NATIONAL HOME BUILDERS REGISTRATION COUNCIL REPORT:

TEMPORARY RESIDENTIAL UNITS IN DUNCAN VILLAGE, EAST LONDON

NHBRC ASSESSMENT REPORT

Report Ref: Duncan Village/01/2020-09

Figure 7: View roof structure

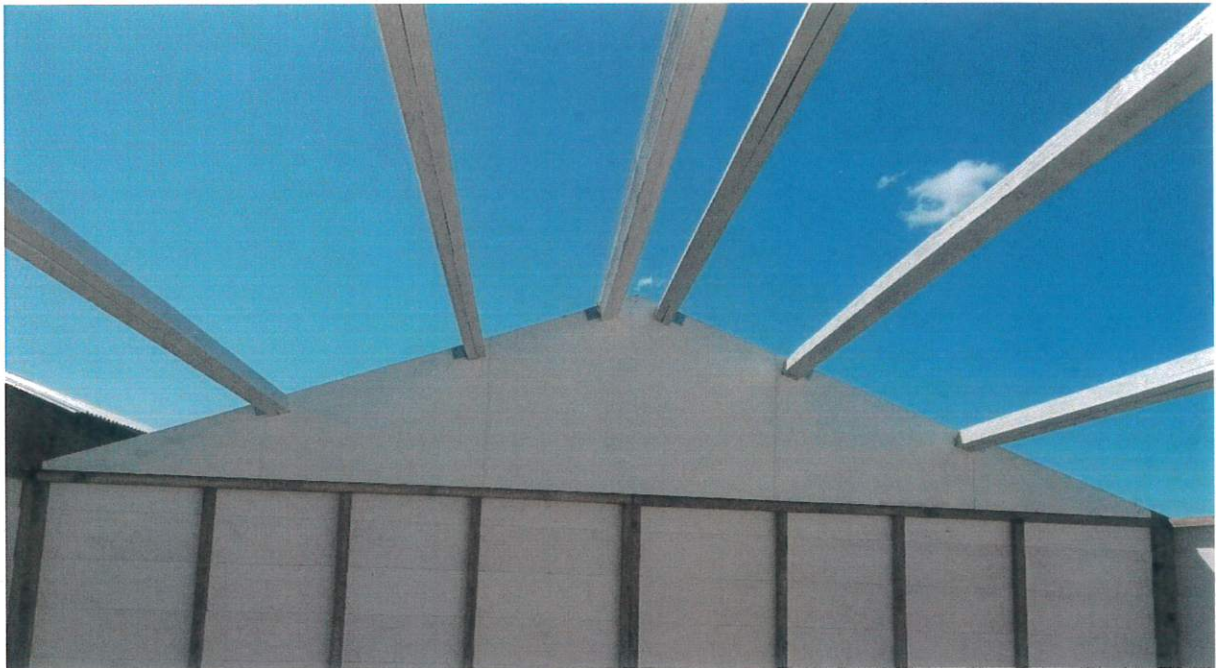
- SANS 10082 indicate that the supporting structure used in the basic roof construction shall be trusses which shall be designed, manufactured and erected in accordance with the relevant parts of SANS 10163 and SANS 10243.

No design was provided for the roof trusses and purlin beams used in the roof construction. The trusses are manufactured using 76mm x 38mm timber screwed together and covered with the magnesium oxide board on both sides. The double 76mm x 38mm purlin beams are connected to the trusses with a metal angle bracket with two screws into the purlin beam and two screws into the truss side.

Figure 8: Middle truss bearing unto external wall

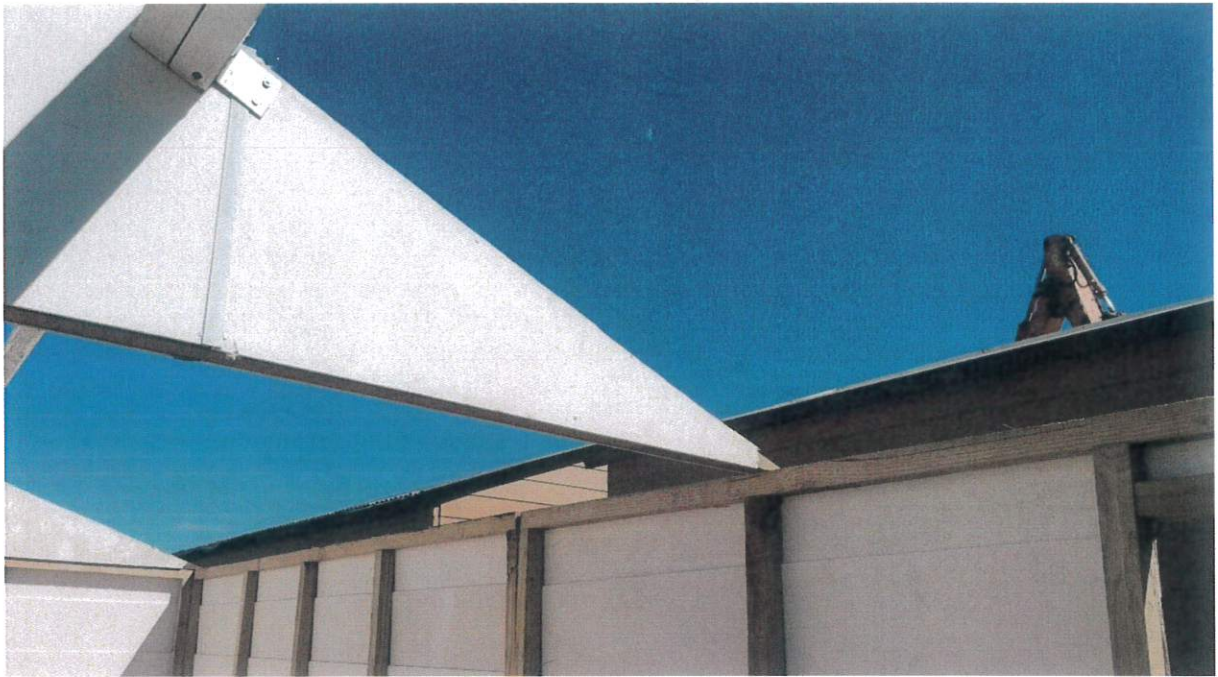
- SANS 10082 indicate anchorage of roof structure to walls. With the requirement of 30mm x1.2mm steel strap or 2 x 4 diameter wires.

The trusses are screwed into the wall panels and no steel straps are used for the anchorage. The middle truss is also not bearing sufficiently on the wall for effective anchorage.

Figure 6: Gaps in internal cladding

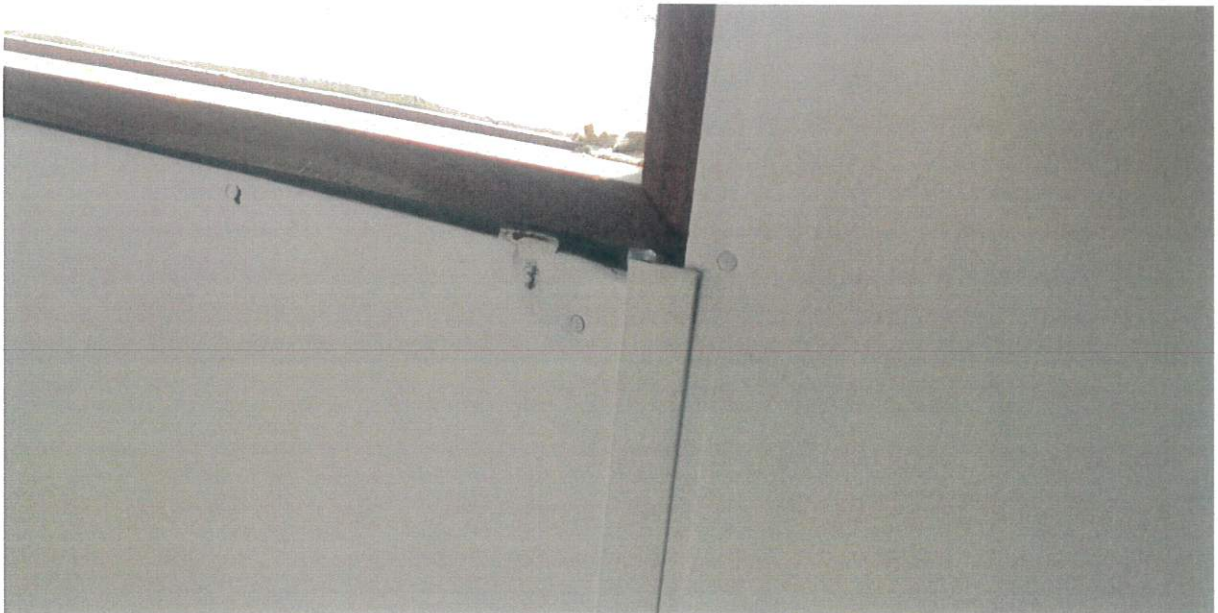
- Internal gypsum board not fitting, gaps opening.

Figure14: Timber splitting

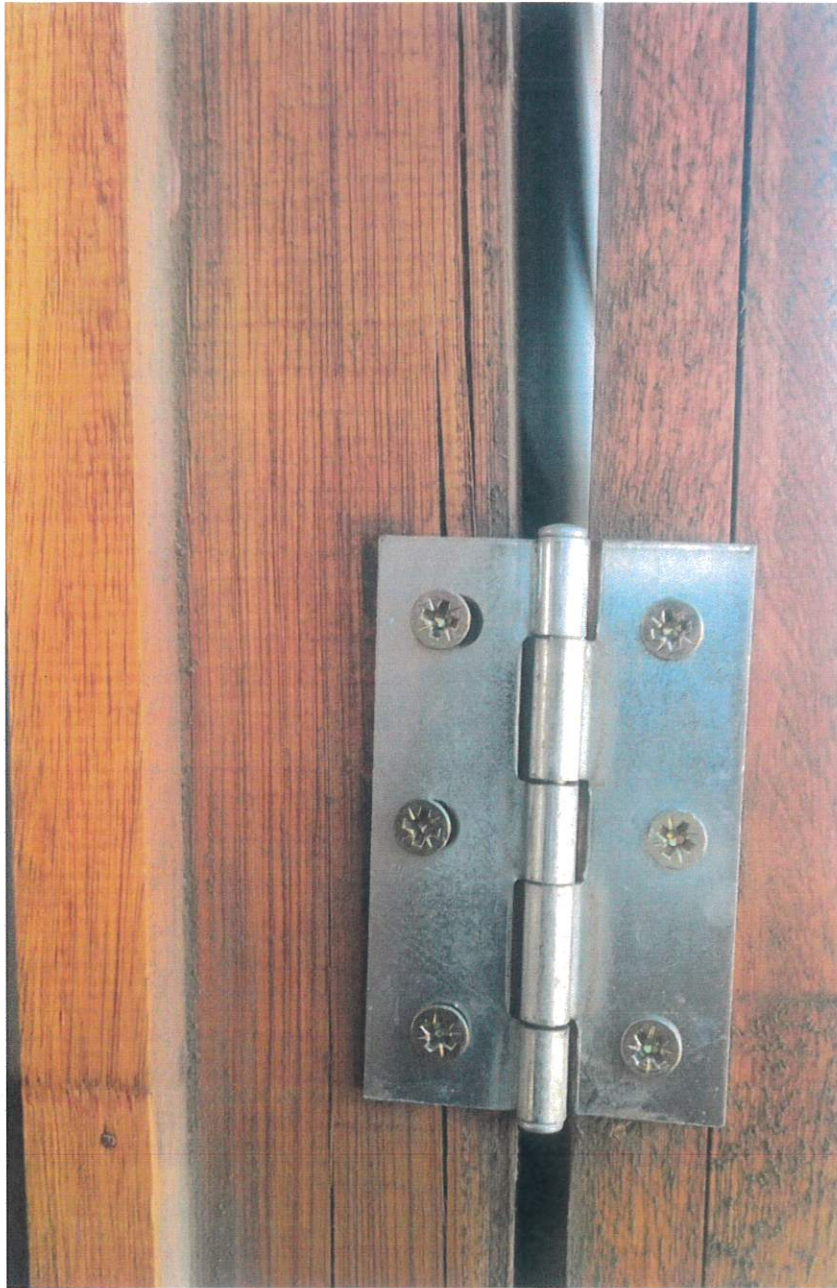
- Timber splitting at screw positions.
